STAFF RECOMMENDATION 1203 Ferguson Avenue February 20, 2013

Application: New construction-addition; Demolition—Accessory structure.
District: Belmont-Hillsboro Neighborhood Conservation Zoning Overlay
Council District: 18
Map and Parcel Number: 11805001300
Applicant: Preston Quirk, Quirk Designs
Project Lead: Melissa Baldock, melissa.baldock@nashville.gov

<p>Description of Project: Application is to construct a rear addition that is taller than the historic house. The project involves removing a non-historic shed and a non-historic metal awning.</p> <p>Recommendation Summary: Staff recommends approval of the structure with the condition that staff review and approve the asphalt shingle color and windows and doors prior to purchase and installation of these materials. With these conditions, staff finds that the project meets Section II.B. and III.B.2. of the <i>Belmont-Hillsboro Neighborhood Conservation District: Handbook and Design Guidelines</i>.</p>	<p>Attachments A: Photographs B: Site Plan C: Elevations</p>
--	--

DEMOLITION PLAN

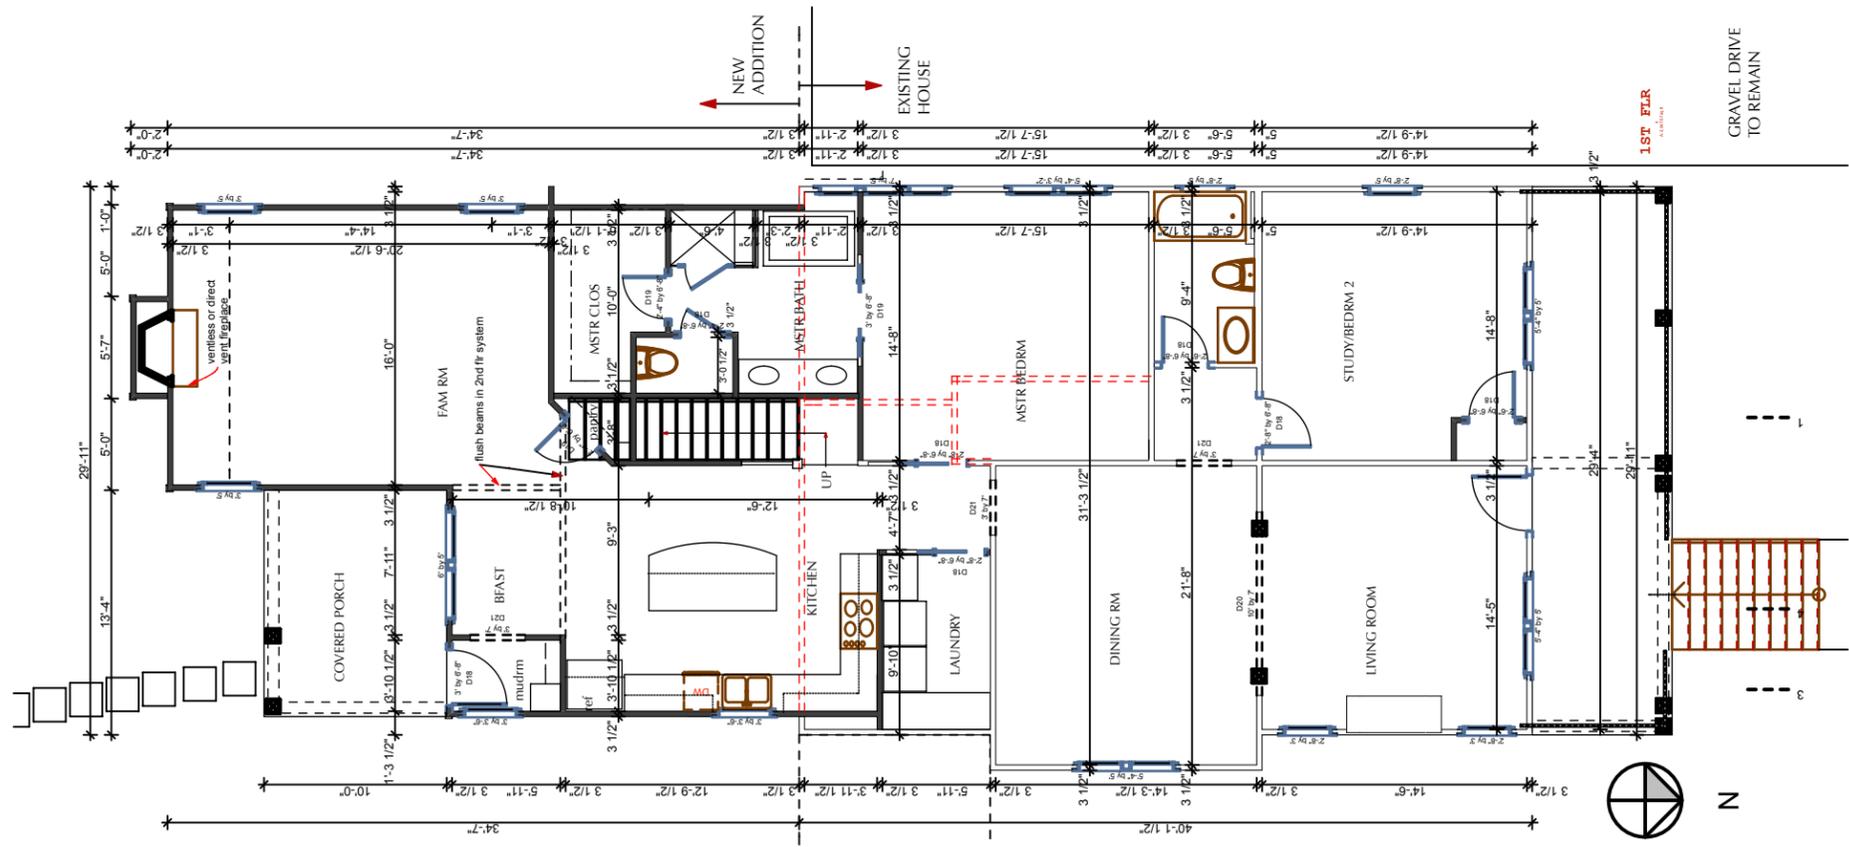
Demolition: The project involves removing an existing shed and an existing metal awning on the side of the house (see Figures 2, 3 & 4 on next page). Both the shed structure and the metal awning lack historic and architectural integrity, and staff finds that their removal meets Section III.B.2. of the design guidelines.

The project also involves removing most of the back wall of the existing house (see Figure 5). The back corners of the house will be retained, allowing for the original form of the house to be discerned. Staff finds that the removal of most of the back wall of the house meets Section III.B.2. of the design guidelines.

ELEV - FRONT, REAR

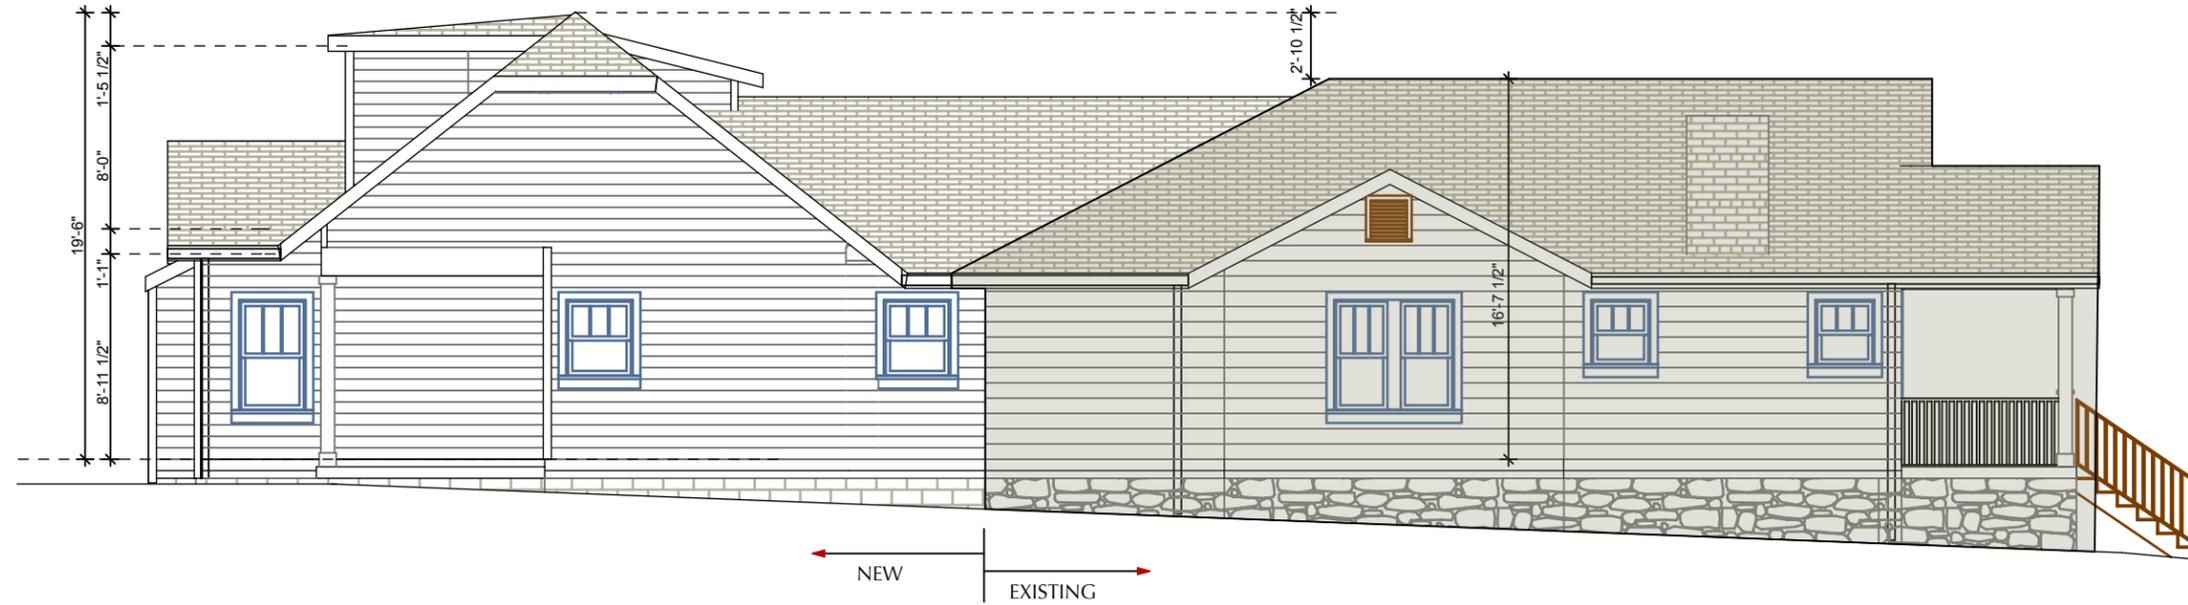
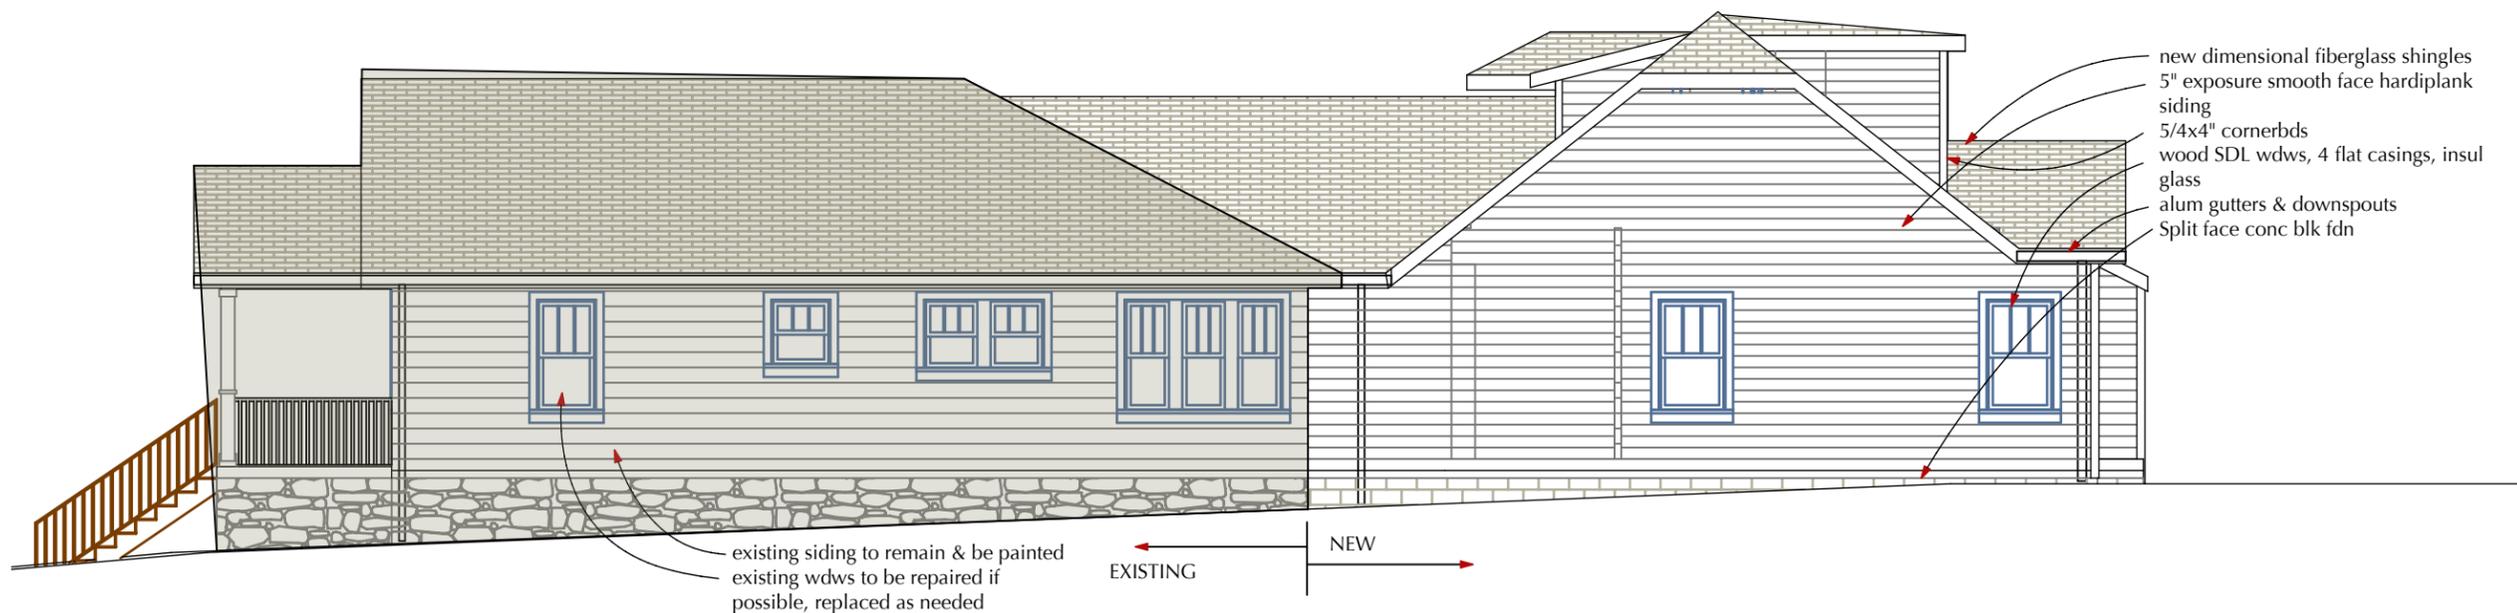
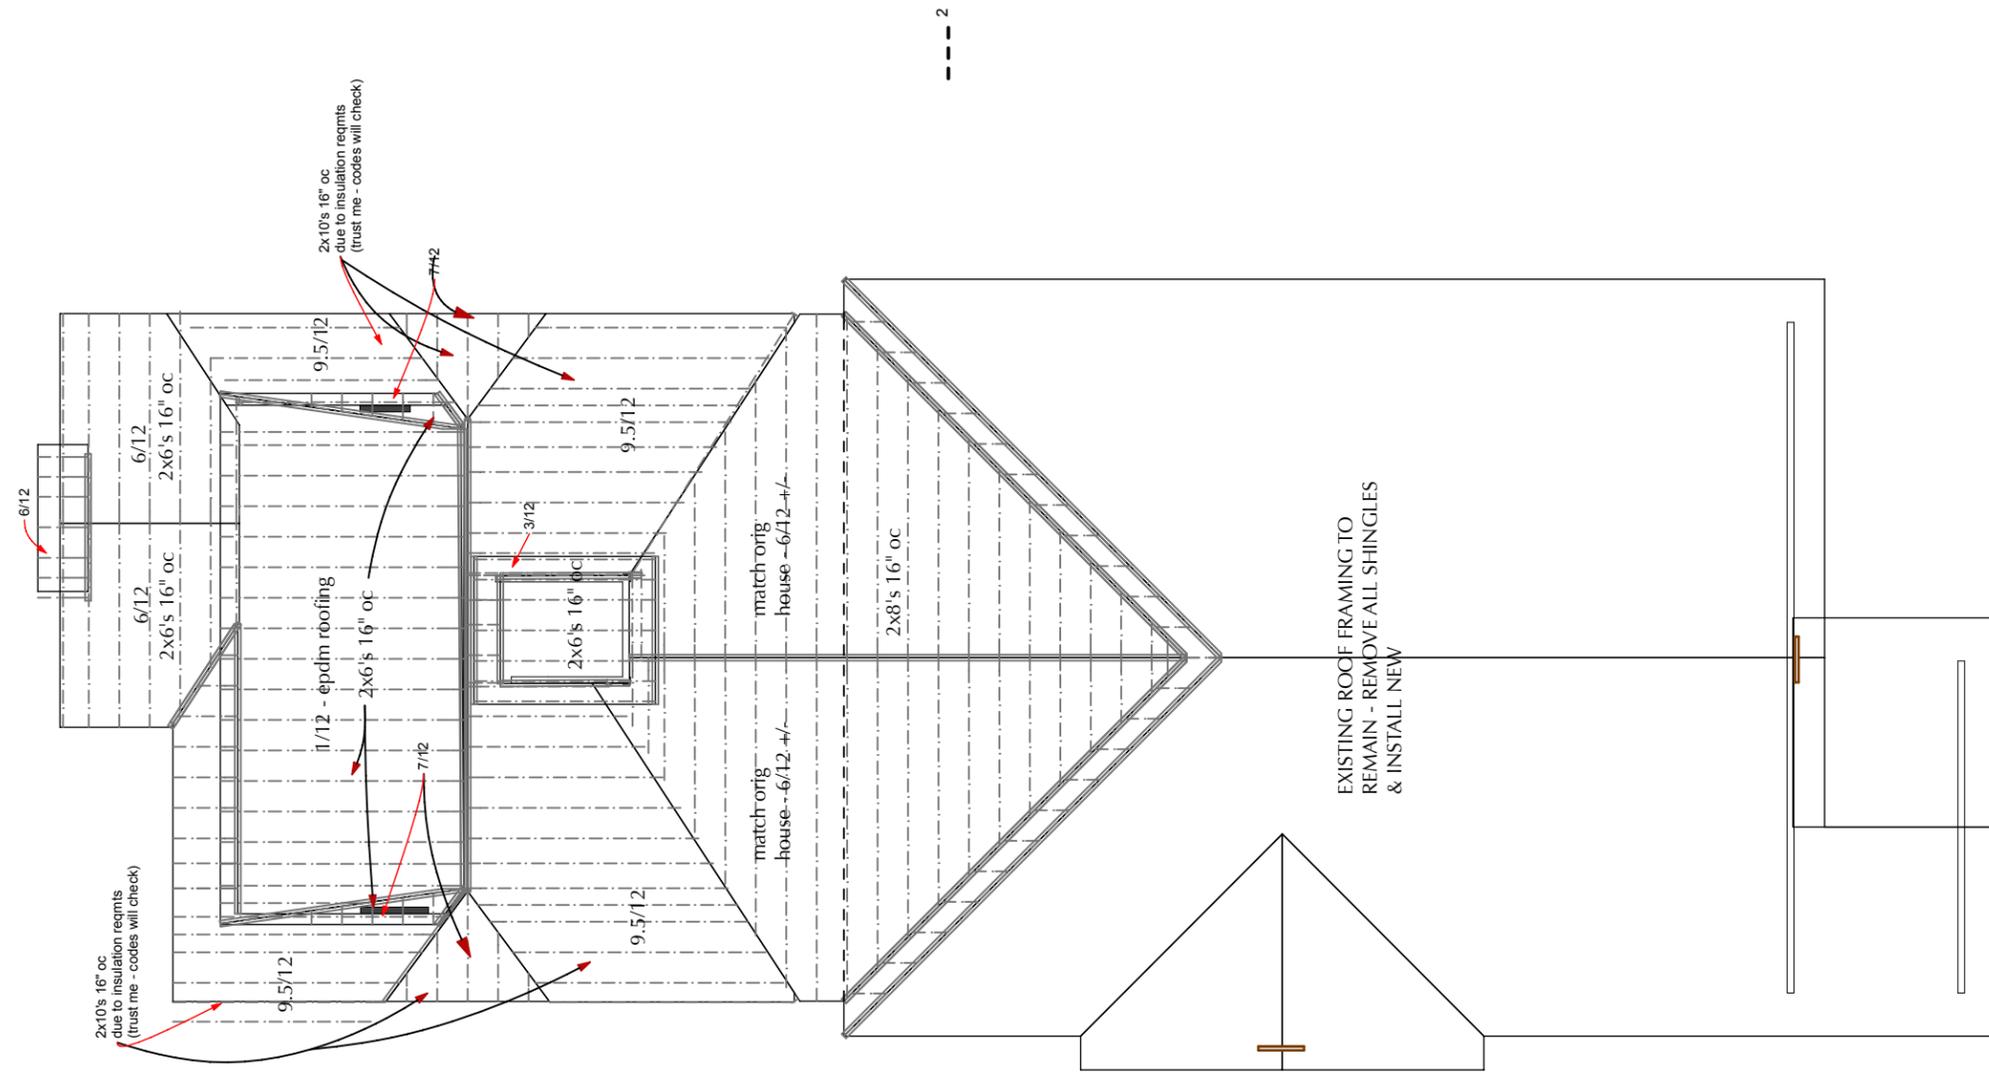
Height, Scale: The existing house has a ridge height of twenty feet, six inches (20'6") from the grade. The addition ties into the house's roof approximately one foot (1') lower than the house's ridge. The addition is proposed to grow in height to be about two feet, ten inches (2'10") taller than the historic house. Staff finds the extra height of the addition to be appropriate because it does not occur until more than sixty feet (60') behind the front wall of the house and because the side gabled roof form will help reduce the visual impact of the extra height. In addition, the taller portion of the addition will

step in from the side walls of the house by one foot (1') on each side. The eave height of the addition will match the eave height of the house at the front of the addition, but will be about one foot, six inches (1'6") taller at the back of the addition, which is appropriate.

Roof Form: The existing house's primary roof form is a front gable with a slope of 6:12. The addition's primary roof form will be a clipped side gable with a slope of 10:12. A rear shed dormer with slope of less than 1:12 will be on the rear façade of the addition. Staff finds that the roof form is compatible with that of the house and with surrounding historic structures, and meets Sections II.B.1.e. and II.B.2. of the design guidelines.

Proportion and Rhythm of Openings: The drawings indicate that the window and door openings on the existing structure will not be altered as part of this project. The windows on the addition are generally twice as tall as they are wide, and there are no large expanses of wall space without a door or window opening. Staff finds that the addition's proportion and rhythm of openings meet Section II.B.1.g. and II.B.2. of the design guidelines.

Staff recommends approval of the structure with the condition that staff review and approve the asphalt shingle color and windows and doors prior to purchase and installation of these materials. With these conditions, staff finds that the project meets Section II.B. and III.B.2. of the *Belmont-Hillsboro Neighborhood Conservation District: Handbook and Design Guidelines*.
